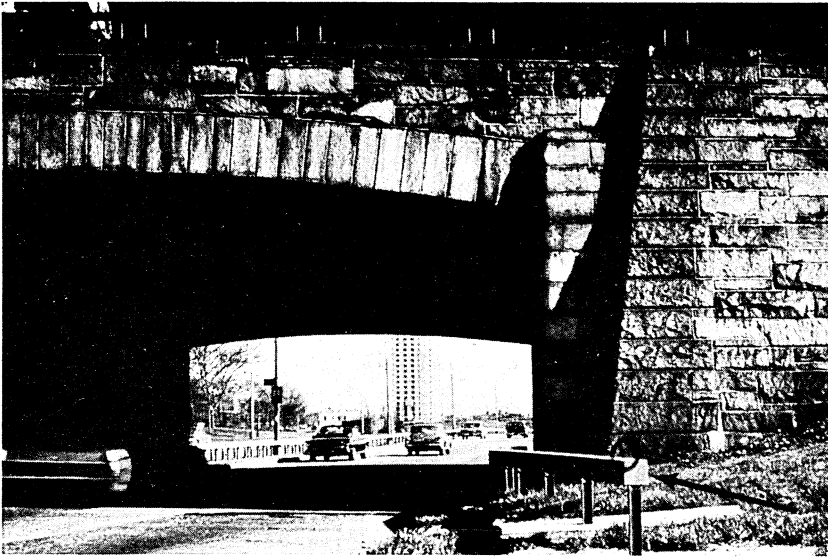
Here you see the brandnew square-type box beam, the best rail we have and I think it is good. They call for burying the end, but because the end is sticking up like that, a car can run right through it.
